MidAmerican Resource Evaluation Study
IEC, ELPC and Sierra Club
September 3, 2024
(PUBLIC VERSION)

**RE: ELPC, IEC and Sierra Club Comments in Response to MidAmerican's
August 5, 2024 Response Comments**

Figure 10. Monthly 12-month inflation rate in the US

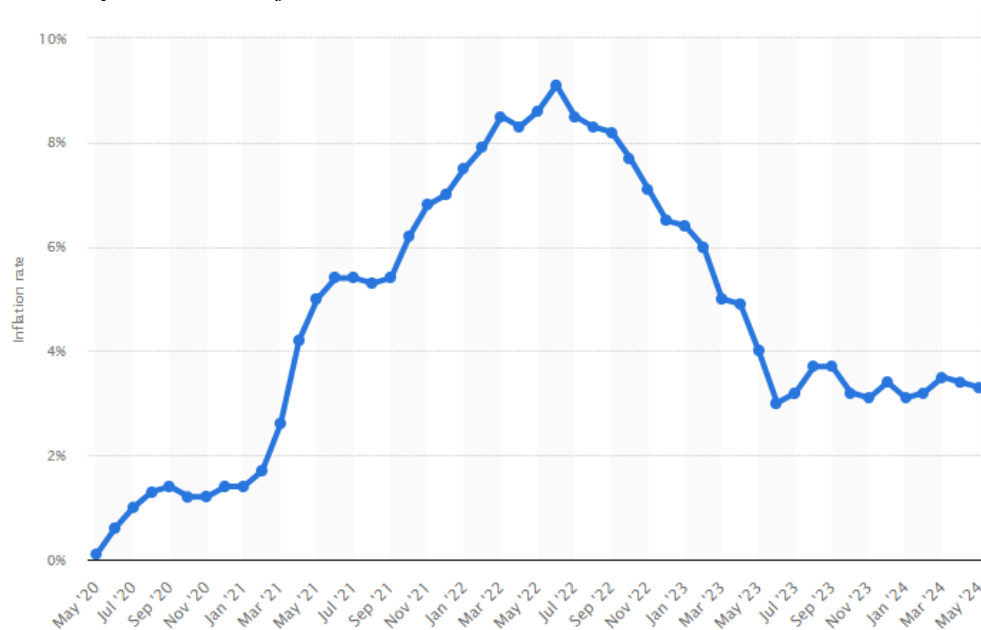
We do not dispute that costs have increased in recent years, and that recent NREL forecasts turned out to be too low. But the renewable cost increase from 2018 to 2023 was the result of a major, unforeseeable, global economic disruption that is being resolved. Today, as depicted in Figure 10 below, inflation is cooling and the Federal Reserve is working to keep inflation at about 2 percent. The price increases seen in recent years are unlikely to continue.

Figure 11. NREL ATB 2015-2019 Wind and Solar costs

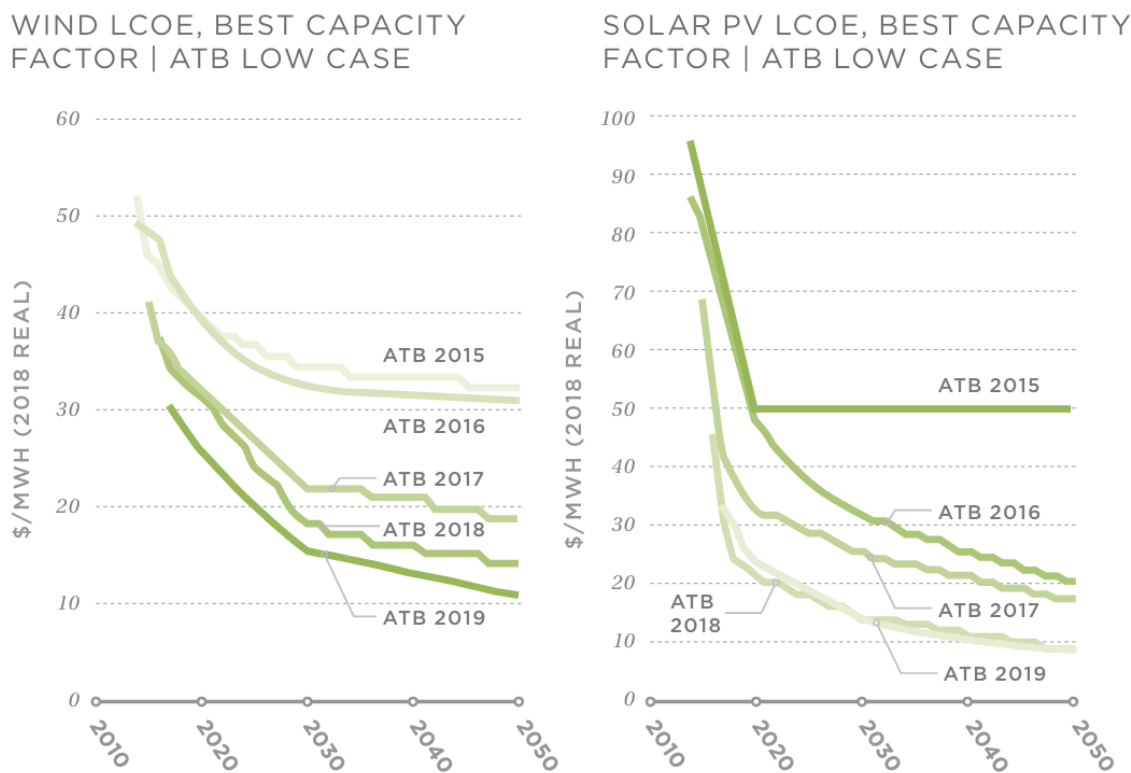
Once the global economy recovers from the recent shock, NREL’s cost forecasts may return to their previous trend of being *consistently higher than actual costs*, as shown in the chart below. Figure 11 below is a comparison of NREL ATB cost forecasts over pre-pandemic years 2015 through 2019, and it demonstrates that NREL, and others, consistently underestimate the cost declines of technology, and have to revise their forecasts further downward each year.
